HISTORIC PRESERVATION

**504 N Hackberry St
Dignowity Hill Historic District**

BOA-24-10300035

An appeal of the Historic Preservation Officer's decision to deny the wholesale replacement of existing one-over-one wood windows on the property and to modify the existing fenestration pattern.

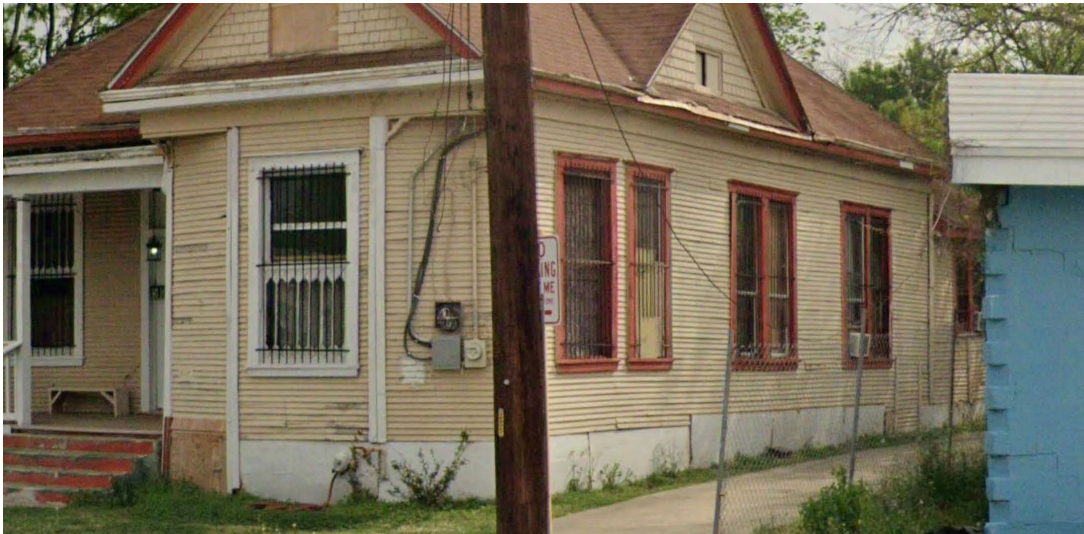
- i. FENESTRATION MODIFICATIONS (WEST) – The applicant is requesting to modify the existing window openings on the west façade. Exterior Maintenance and Alterations 6.A.i. states to preserve existing window openings and to avoid enlarging or diminishing to fit stock sizes. Staff finds the proposed modifications to the window openings on the west façade do not conform to guidelines.

- j. FENESTRATION MODIFICATIONS (SOUTH) – The applicant is requesting approval to infill three windows and modify five window openings on the south façade. Exterior Maintenance and Alterations 6.A.i. states to preserve existing window openings and to avoid enlarging or diminishing to fit stock sizes. Exterior Maintenance and Alterations 6.A.iii. states to preserve historic windows. Exterior Maintenance and Alterations 6.A.iv. states to install new windows to match the historic or existing windows in terms of size, type, configuration, material, form, appearance, and detail when original windows are deteriorated beyond repair. Staff finds the proposed fenestration modifications to the south façade does not conform to guidelines.

- k. FENESTRATION MODIFICATIONS (NORTH) – The applicant is requesting approval to infill two windows, add one window opening, and modify two window openings on the north façade. Exterior Maintenance and Alterations 6.A.i. states to preserve existing window openings and to avoid enlarging or diminishing to fit stock sizes. Exterior Maintenance and Alterations 6.A.iii. states to preserve historic windows. Exterior Maintenance and Alterations 6.A.iv. states to install new windows to match the historic or existing windows in terms of size, type, configuration, material, form, appearance, and detail when original windows are deteriorated beyond repair. Staff finds the proposed fenestration modifications to the north façade does not conform to guidelines.

Office of Historic Preservation staff does not recommend approval of the appeal. Staff recommends that the Board of Adjustment uphold the Historic and Design Review Compliance and Technical Advisory Board's and the Historic Preservation Officer's denial of a Certificate of Appropriateness for the wholesale replacement of the property's wood windows and modifications to the existing fenestration pattern.
